SOUTH ADAMS COUNTY
WATER AND SANITATION DISTRICT

LIFT STATION NO. 2 EXPANSION

ADDENDUM NO. 1

WALL OR SLAB SLEEVE J

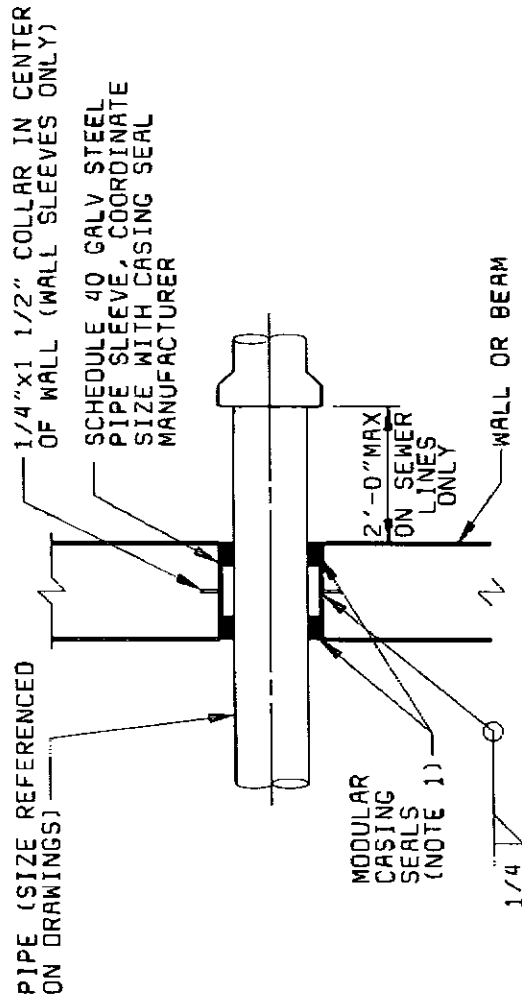
- a. In Section 1, for the sleeve detail where the 12-inch discharge pipe exits the building, refer to Detail J in Attachment 1 of this Addendum No. 1. The elbow encased in concrete inside the building below the floor shall be restrained joint or flanged.

- b. In Section 1, where the 30-inch sewer enters the wetwell, change the detail for the wall penetration to Detail J in Attachment 1 of this Addendum No. 1.
